SERVICE BULLETIN

TITLE: FUSELAGE - WING FORWARD SPAR CARRY-THRU STRUCTURE INSPECTION AND/OR REINFORCEMENT

This Service Bulletin has been revised and is produced in the new format for Raytheon Aircraft Company Service Bulletins. Relevant technical changes are marked with change bars in the outside margins. The prior release of this Service Bulletin allowed for continued flight with known cracks that met specific criteria, and required a 500 flight hour recurring inspection. At the request of the Federal Aviation Administration (FAA), this Service Bulletin has been revised to remove the allowable crack limits that were permitted in prior releases of this Service Bulletin (SB No. 2269 and SB No. 2269, Rev. 1). If any crack(s) are discovered or are known to still be present from a previous inspection, this Service Bulletin revision requires that the crack(s) must be repaired by installation of the applicable P/N 58-4008 Kit(s) within the compliance times specified under ACCOMPLISHMENT INSTRUCTIONS in this Service Bulletin. If no cracks are discovered, this Service Bulletin revision continues to require re-inspection of the wing forward spar carry-thru structure forward and aft frames

Inspection for Cracks in the Wing Forward Spar Carry-Thru Structure Forward and Aft Frames

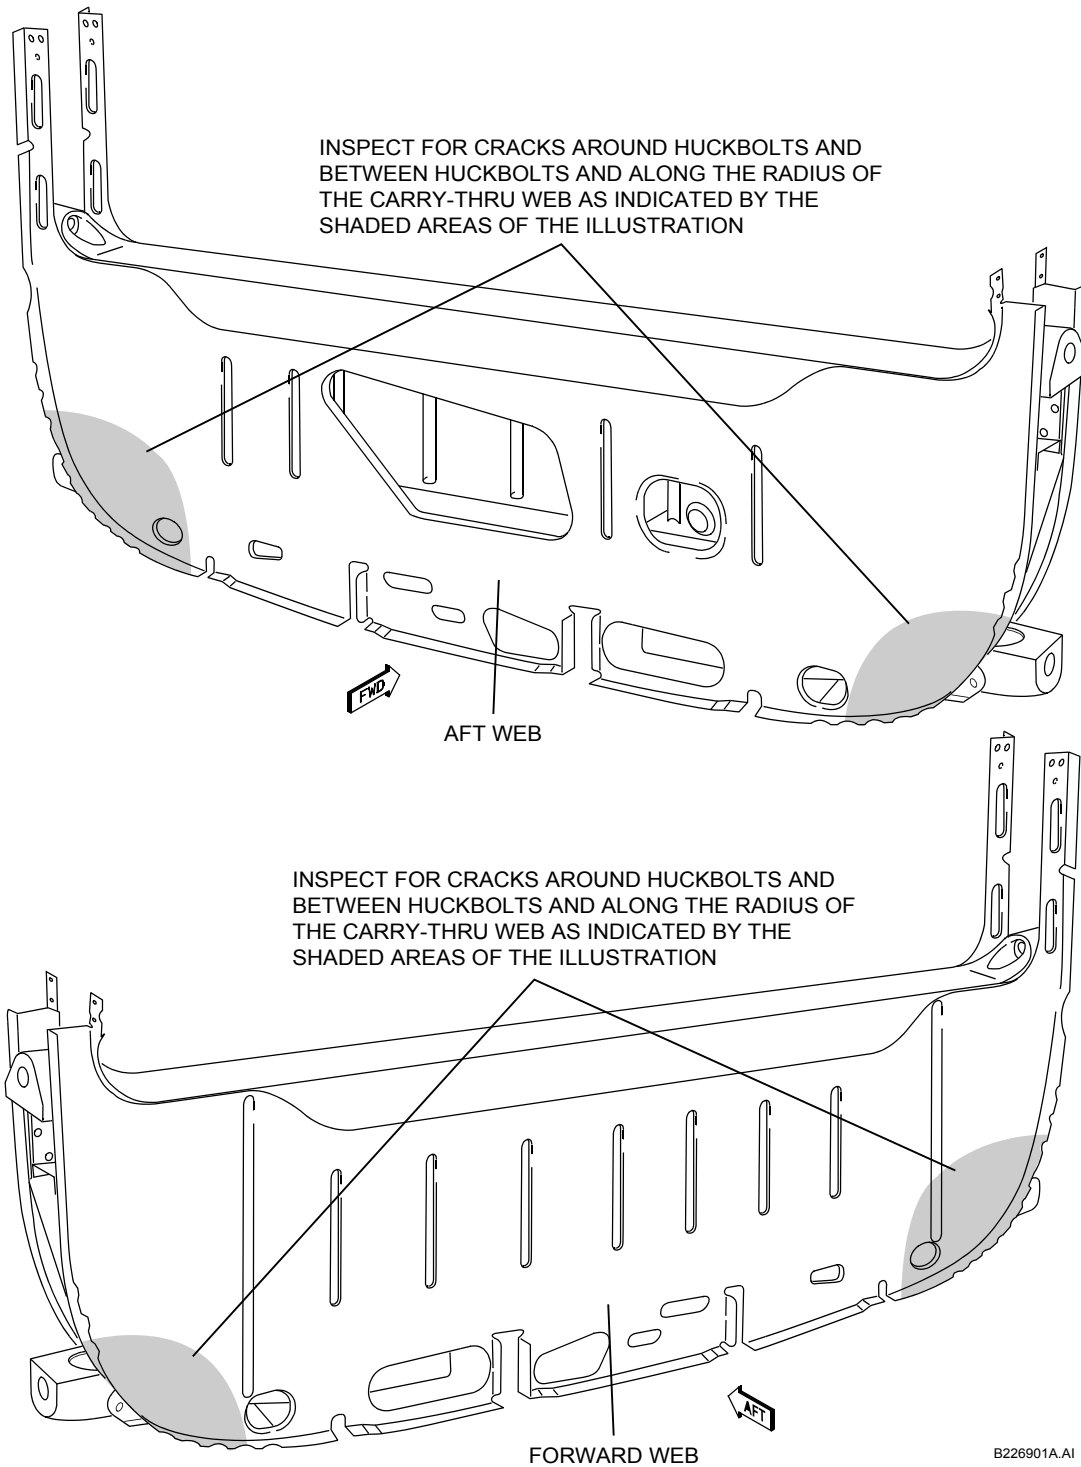
- (2) Remove the pilot's and copilot's seats and the carry-thru cover to obtain access to the front spar carry-thru structure.
- (3) Thoroughly clean the forward and aft frames (webs) of the front spar carry-thru structure in the shaded areas shown in Figure 1.
- (4) Perform a visual inspection of the area cleaned in step 3 for evidence of cracks.
- (5) Perform a dye penetrant inspection using visible dyes, of the area cleaned in step 3 for evidence of cracks.

Any of the shaded areas shown in Figure 1 that are modified by the installation of a doubler need not be dye-penetrant inspected until 1500 flight hours after the installation of that particular doubler. If no cracks are found, repeat the inspection every 500 flight hours.

Cracks found in the shaded areas of Figure 1 that have not been modified by a doubler must be repaired as indicated in this Service Bulletin on an individual basis.

The extent of repair is limited to cracking in the radius of the web flange and cracks in the web flat areas at the fasteners of the lower front spar cap.

- (a) For cracks in the bend radius:
 - (i) A crack up to 4.0 inches in length shall be stop drilled at the ends using a #30 drill bit. The area is to be repaired per the applicable P/N 58-4008 Kit(s) within the next 100 flight hours, 12 calendar months or the next scheduled inspection whichever occurs first.

- (ii) A crack exceeding 4.0 inches in length shall be repaired PRIOR TO FURTHER FLIGHT per the applicable P/N 58-4008 Kit(s).

- (b) For cracks in the web face, in the area of the huckbolt fasteners:
 - (i) A crack emanating from one fastener in two directions is considered to be one crack. **Do not stop drill, due to the possibility of damaging structure behind web face.**
 - (ii) Any crack shall be repaired per the applicable P/N 58-4008 Kit(s), within the next 25 flight hours, 12 calendar months or the next scheduled inspection whichever occurs first.
 - (iii) A crack passing through two fasteners and extending beyond for more than 0.5 inch on either end shall be repaired PRIOR TO FURTHER FLIGHT, per the applicable P/N 58-4008 Kit(s).
 - (iv) A crack passing through two fasteners and extending beyond for less than 0.5 inch on both ends shall be repaired per the applicable P/N 58-4008 Kit(s), within the next 25 flight hours, 12 calendar months or the next scheduled inspection whichever occurs first.

- (c) If cracks are found in both the forward and aft frames on the same side of the airplane, in either the web face and/or the bend radius, and any of the cracks are more than 1.0 inch long, a repair shall be made PRIOR TO FURTHER FLIGHT.

- (d) If cracks are found in both the forward and aft frames on the same side of the airplane, in either the web face and/or the bend radius, and all of the cracks are less than 1.0 inch long, a repair shall be made per the applicable P/N 58-4008 Kit(s) within the next 25 flight hours, 12 calendar months or the next scheduled inspection whichever occurs first.
